**ADDENDUM No. 2**

Date: June 5, 2026

Project: Hector International Airport  
Terminal Apron Reconstruction – Phase 2

**4 EXISTING VALVE MANHOLE 4 REMOVALS**  
1" = 2'

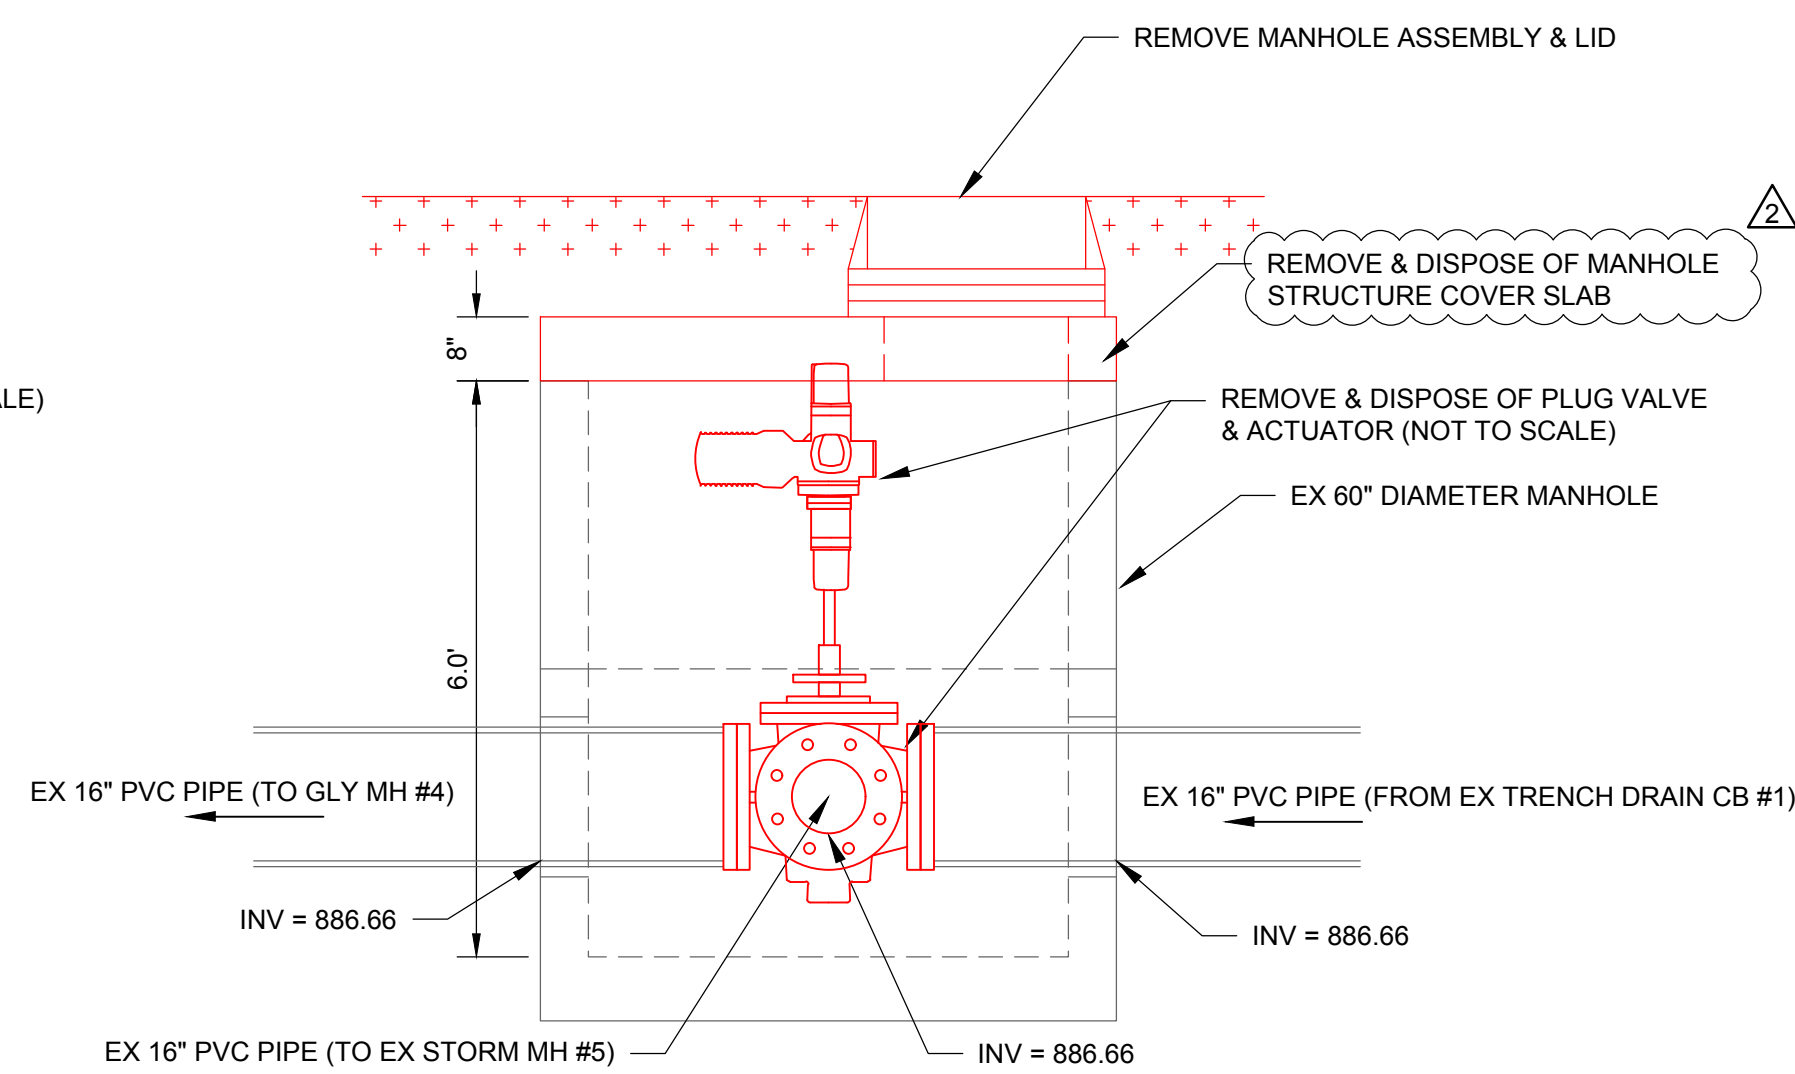
### **5. Sheet C-453 EXISTING VALVE MANHOLE REMOVALS**

- I. Add more leaders clarifying removals
- II. Correct existing pipe labels
- III. Add notes 5 and 6

**C-455**

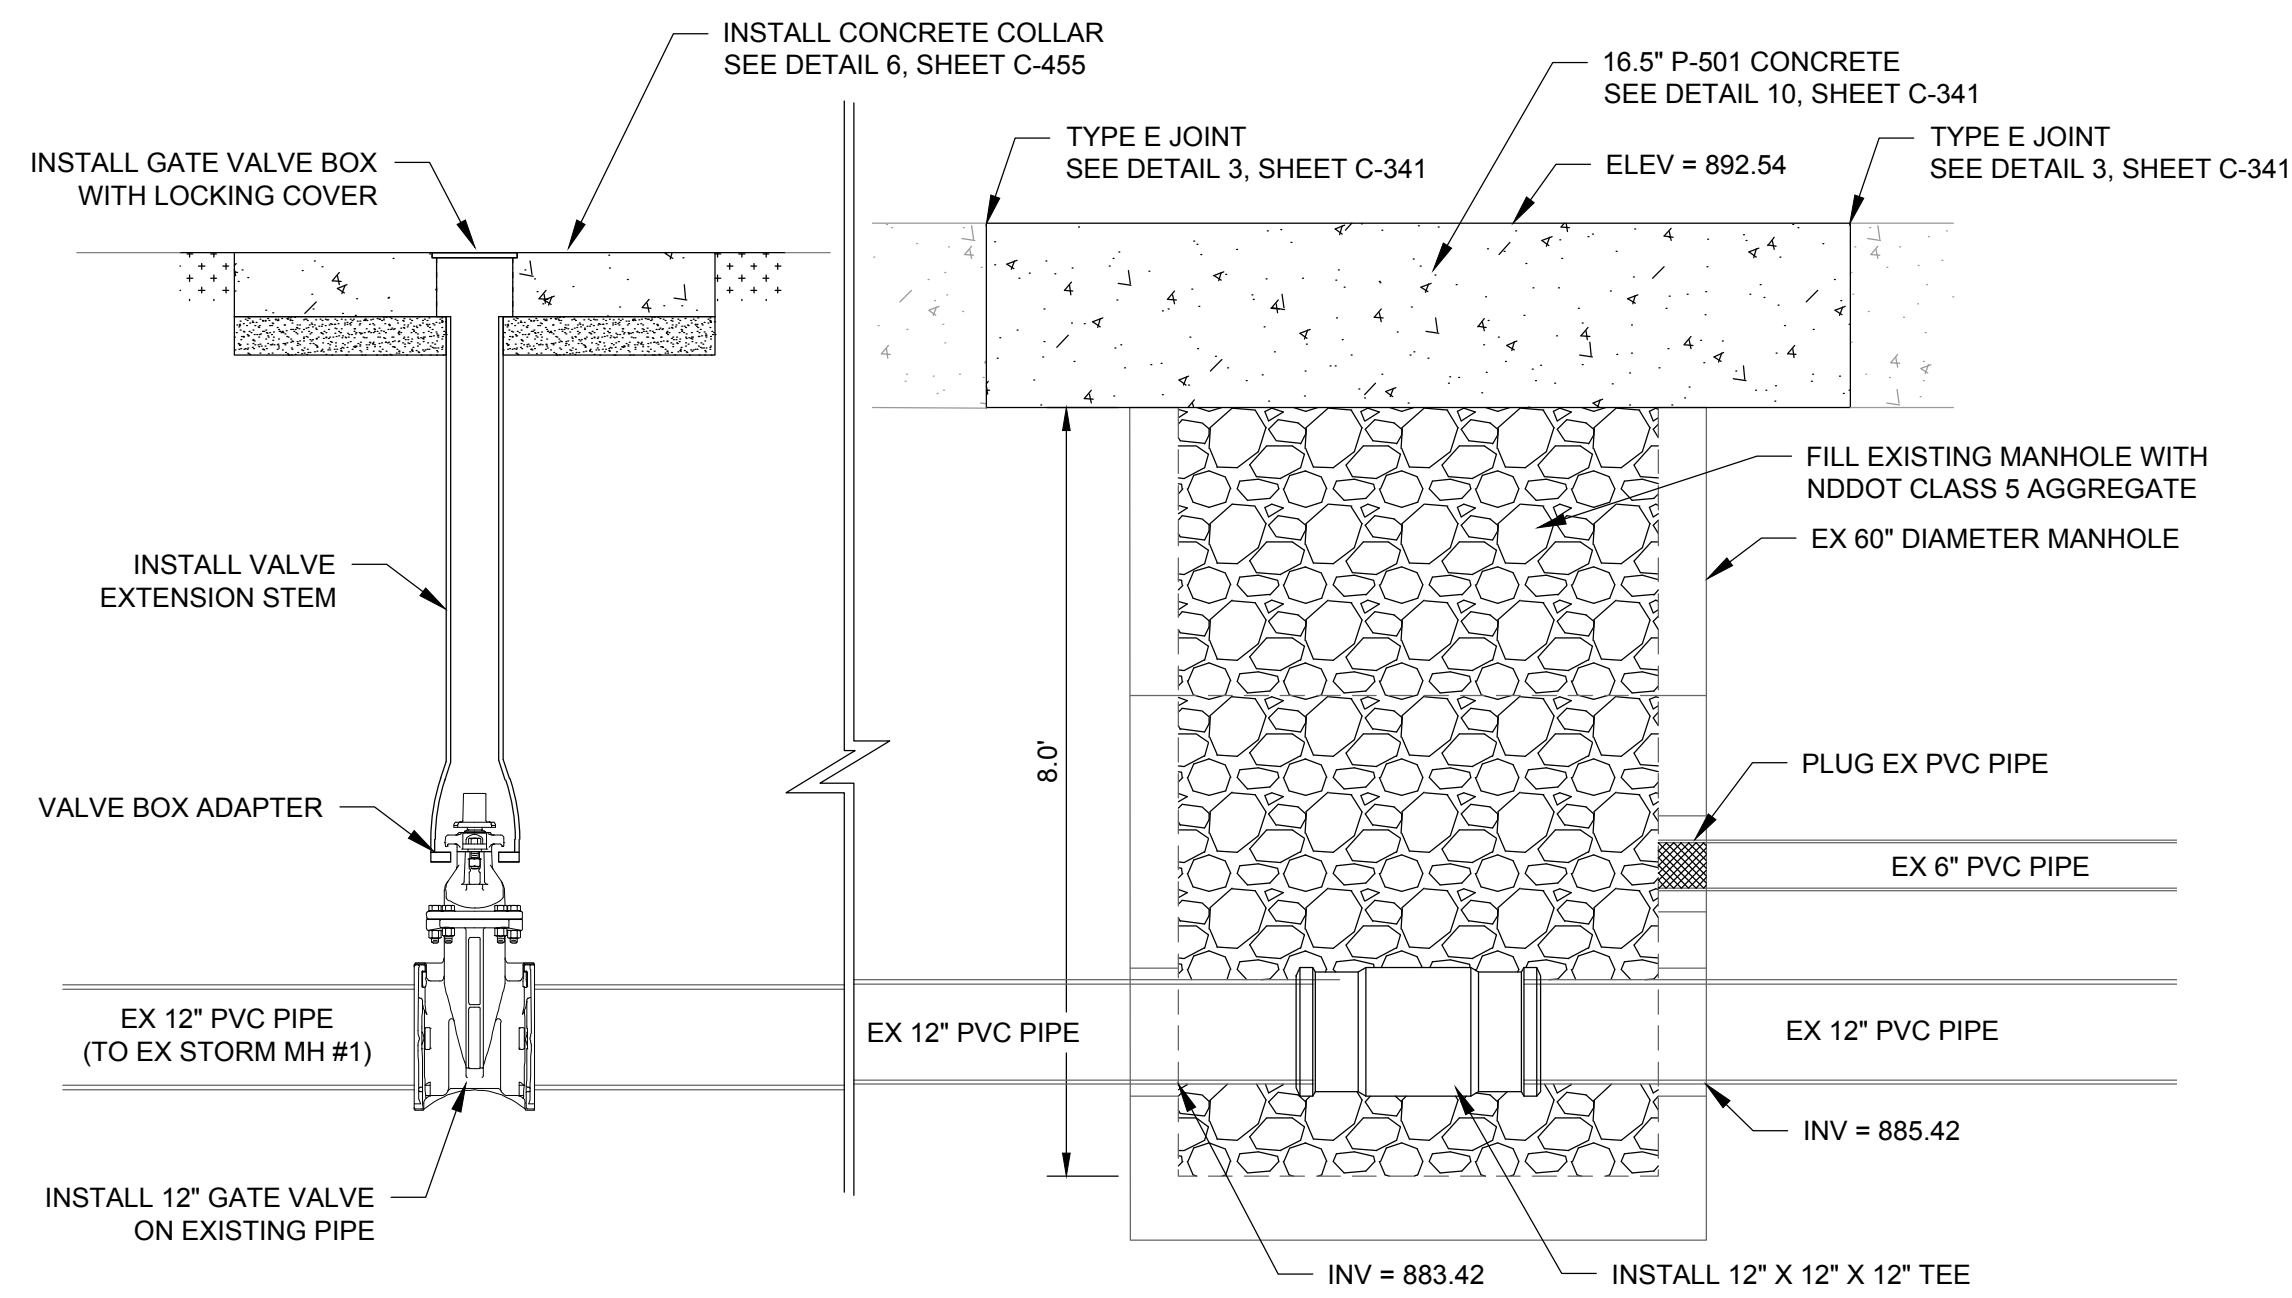
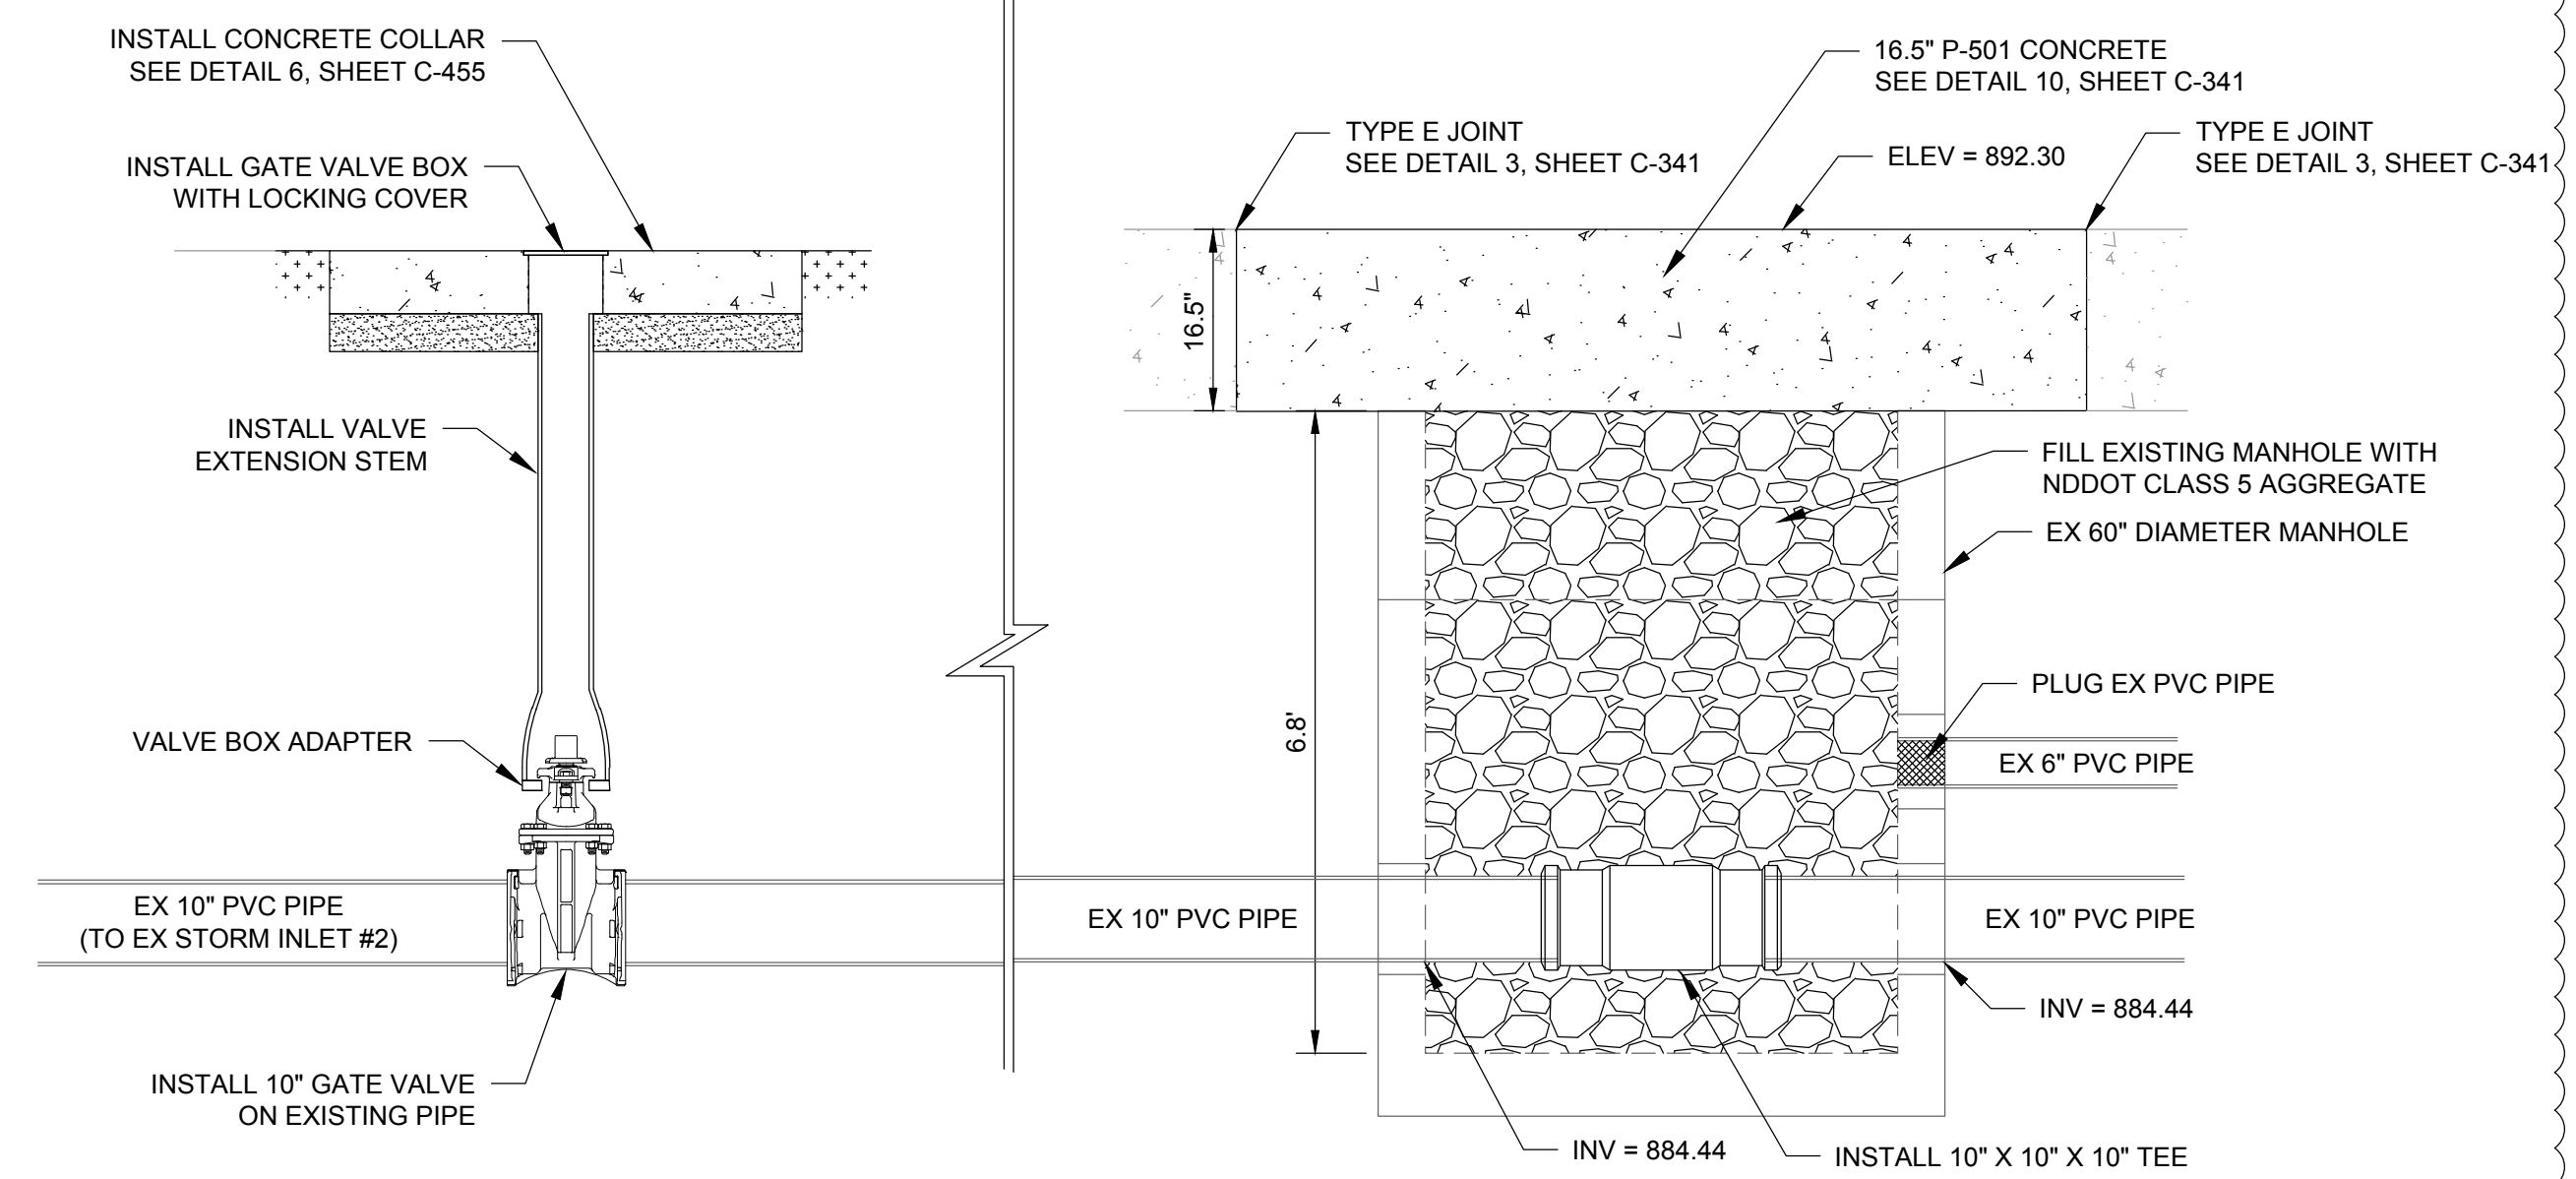
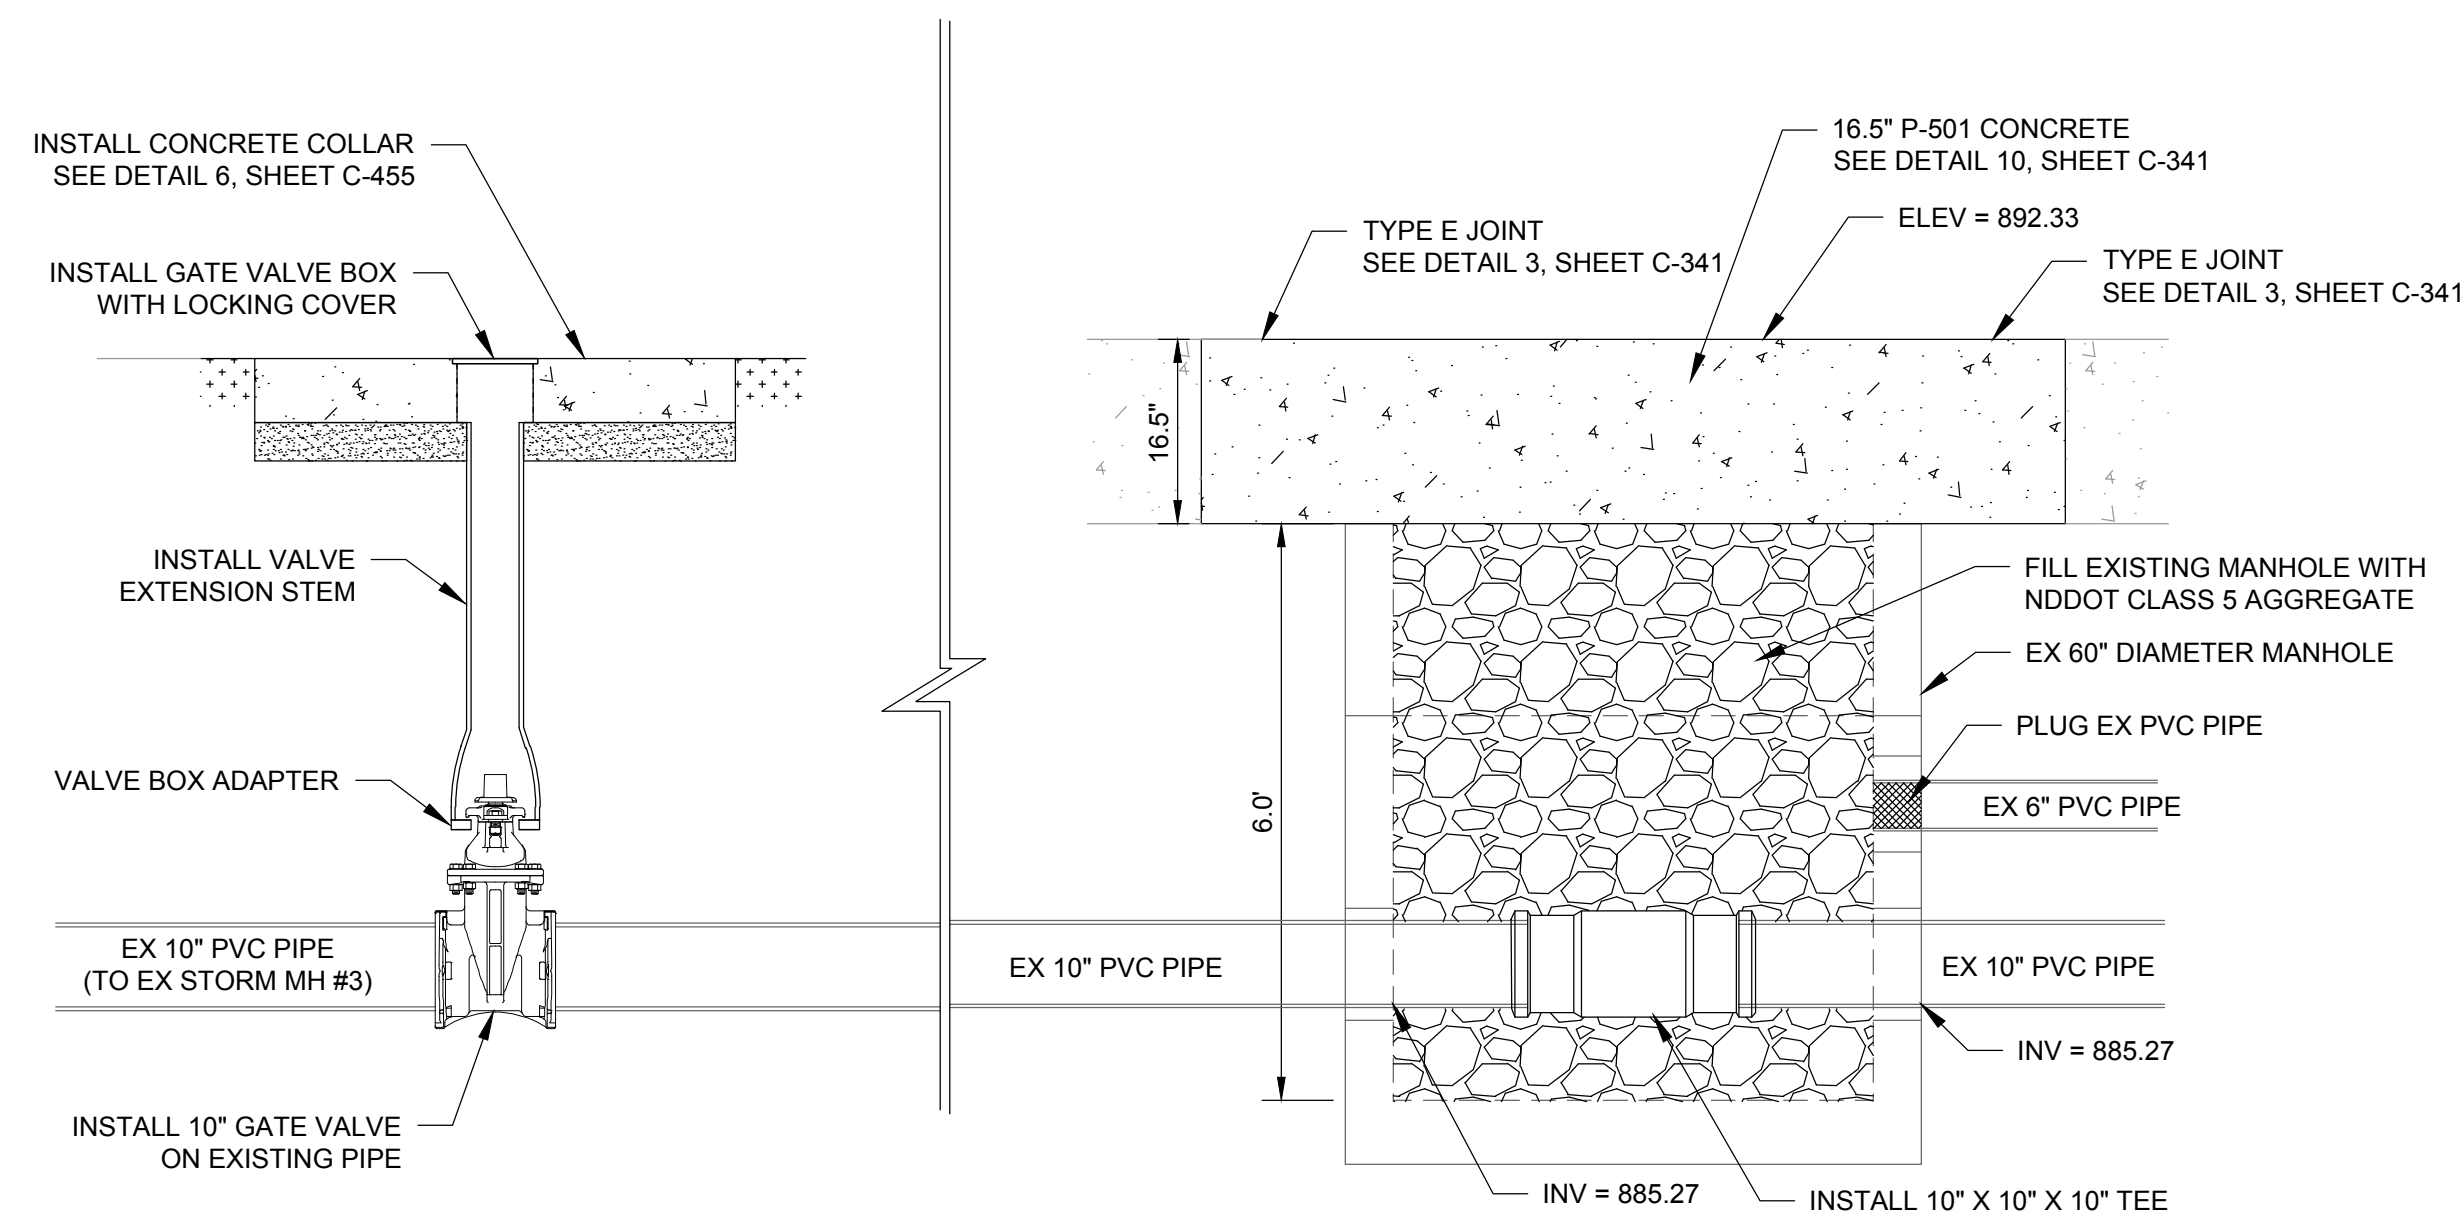
**7. Sheet C-455 VALVE MANHOLES MODIFICATIONS**

- A. Add sheet
- B. Changes include
  - I. Moved Detail 5 *Existing Valve Manhole 5 Modification* from sheet C-454
  - II. Added Detail 6 *Gate Valve Cover Concrete Collar*
  - III. Revised notes
